Access Compliance Report

Public Rights-of-Way

(Curb Ramps)

Intersection ID: N/A	Main Street: 3RD_ST	Cross Street: JOHN_BELK_FY	Location: N
ADA ID: BBD3BDDF6B96	Ramp Type: Perp	Initial Pass/Fail: Pass	Overall Compliance: No
		Severity Score: 6.25

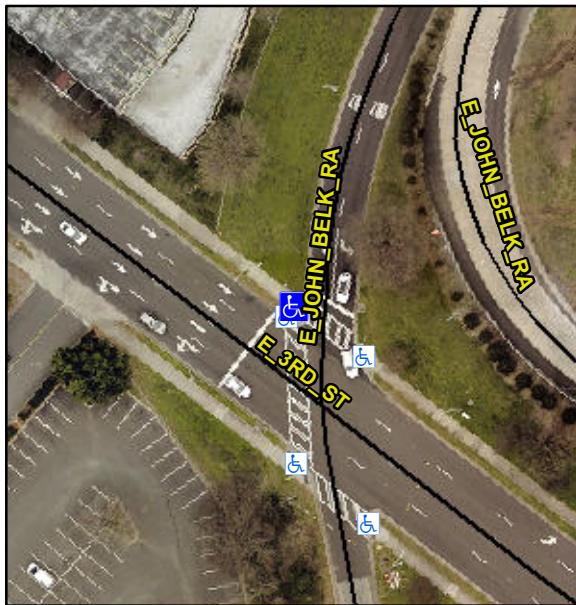
R304.2.1, R304.5.3

Remove & Replace Landing.
